Access Compliance Report

Public Rights-of-Way

Intersection ID: 15175	Main Street: SOUTH_BV	Cross Street: POINDEXTER_DR	Location: NW
ADA ID: 8F4D786FD42D	Ramp Type: Perpendicular	Initial Pass/Fail: Fail	Overall Compliance: No
			Severity Score: 13.75

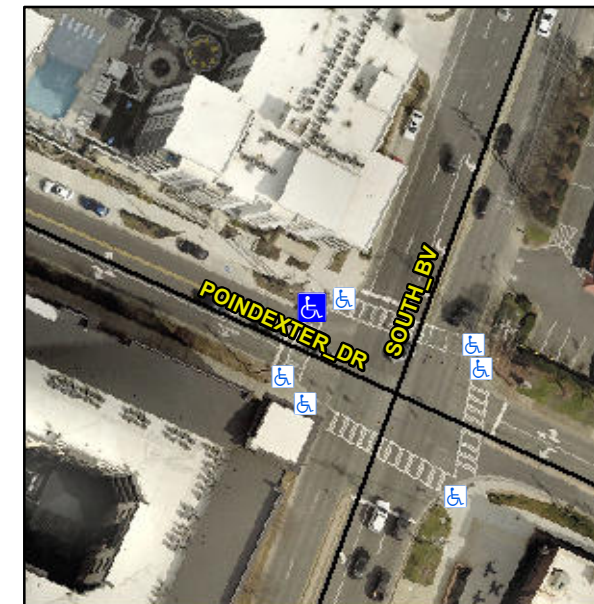
Not Found, R304.2.2

Compliance	Description	Data	Compliance	Description	Data
N/A	Ramp Length (in)	80.0	No	Ramp Slope (%)	8.8
Yes	Ramp Width (in)	49.0	Yes	Ramp XSlope (%)	2.7
N/A	Flare Type LT	N/A	N/A	Flare Type RT	N/A
N/A	Flare Slope LT (%)	N/A	N/A	Flare Slope RT (%)	N/A
N/A	Flare Traversable LT?	N/A	N/A	Flare Traversable RT?	N/A
N/A	Landing Length (in)	N/A	N/A	DWS Provided?	N/A
N/A	Landing Width (in)	N/A	N/A	DWS Contrast?	N/A
N/A	Landing Slope (%)	N/A	N/A	DWS Length (in)	N/A
N/A	Landing X Slope (%)	N/A	N/A	DWS Full Width?	N/A
N/A	Landing Curb? (Y/N)	N/A	N/A	DWS Offset (in)	N/A
N/A	Shared Landing?	N/A			
N/A	Gutter Ponding?	N/A	N/A	Gutter Slope (%)	N/A
N/A	Gutter Lip Ht (in)	N/A	N/A	Gutter X Slope (%)	N/A
N/A	Painted X Walk1?	Yes	N/A	Painted X Walk2?	N/A
	X Walk 1 Direction	To SW		X Walk 2 Direction	N/A
N/A	X Walk 1 Width (in)	106.0	N/A	X Walk 2 Width (in)	N/A
	X Walk 1 Slope (%)	2.6		X Walk 2 Slope (%)	N/A
	X Walk 1 X Slope (%)	4.0		X Walk 2 X Slope (%)	N/A

Remove & Replace Entire Ramp.
